# CITY OF ALBUQUERQUE

**Re: Clean Machine Car Wash  
6016 Central Ave SE  
Traffic Circulation Layout  
Engineer's 11-02-16 (K18-D079)**

**SITE PLAN**

SHEET NO:  
**C101**

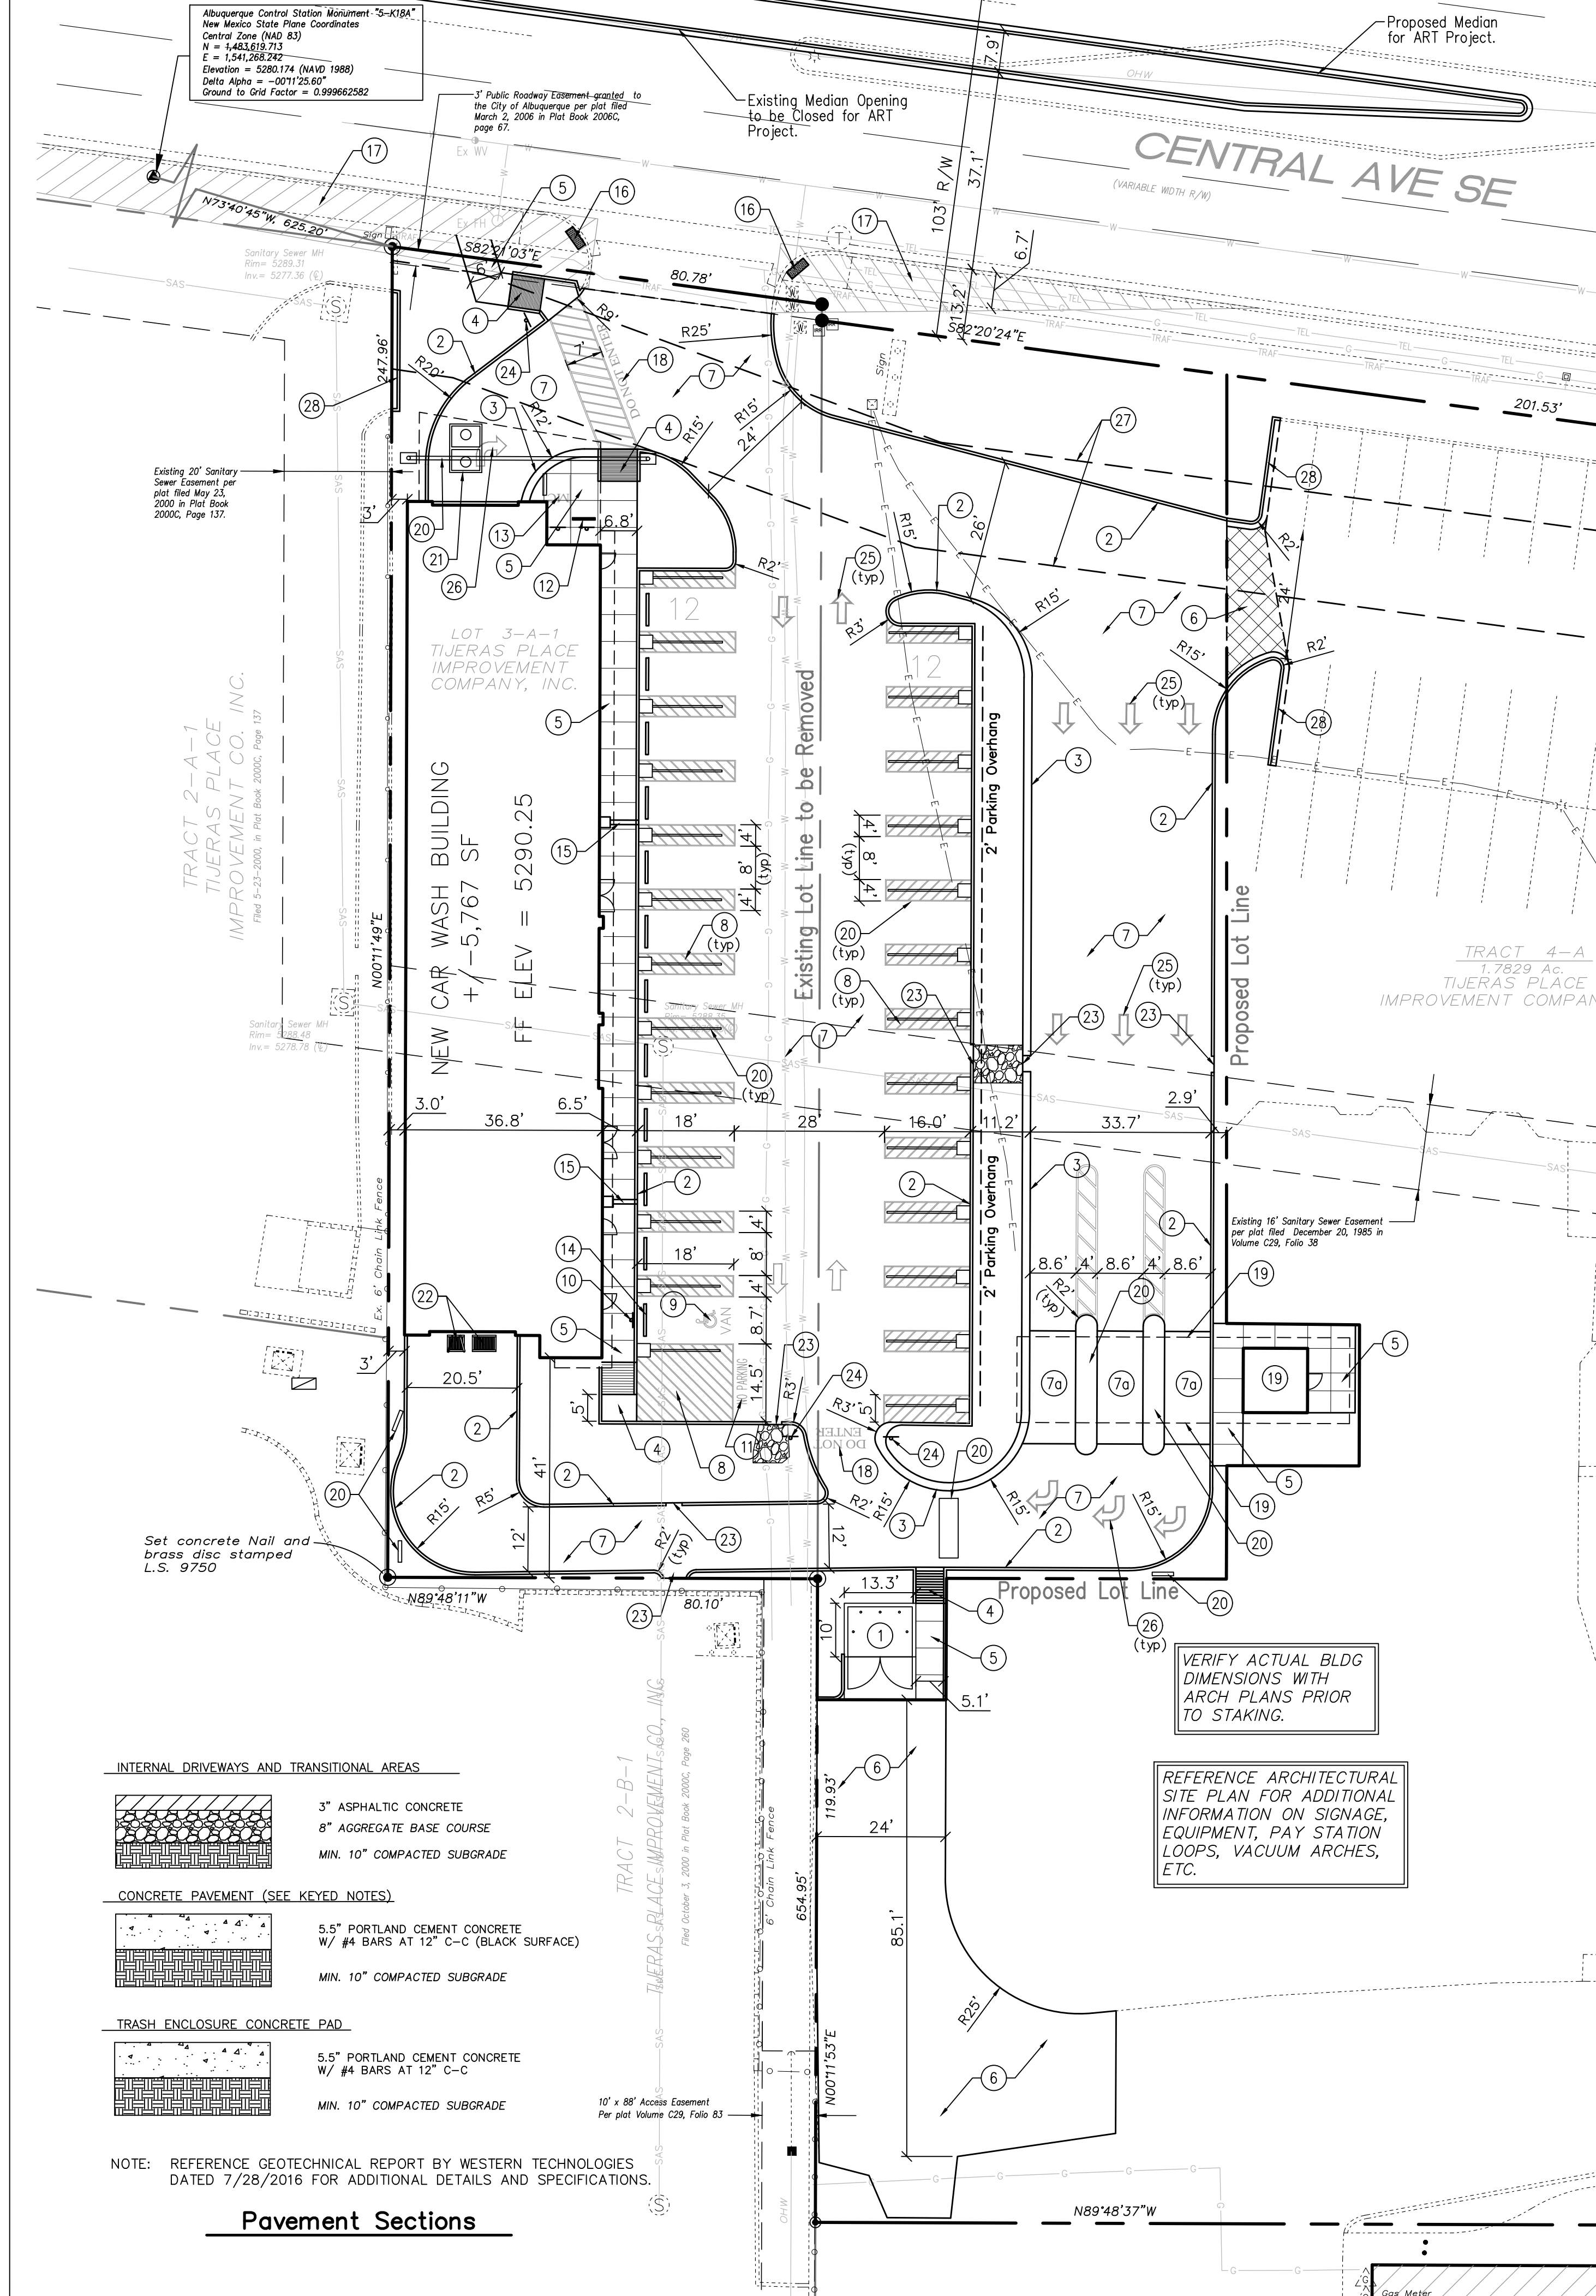
The TCL submittal received 11-02-16 is approved for Building Permit. A copy of the stamped and signed plan will be needed for each of the building permit plans. Please keep the original to be used for certification of the site for final C.O. for Transportation.

1. Final acceptance and approval of the replat of tract 4-A1, 4-A-2 and 8-A section 24, township 10 north, range 3 east New Mexico Principal Meridian, City of Albuquerque, Tijeras Place Improvement Company, Inc. from DRB.
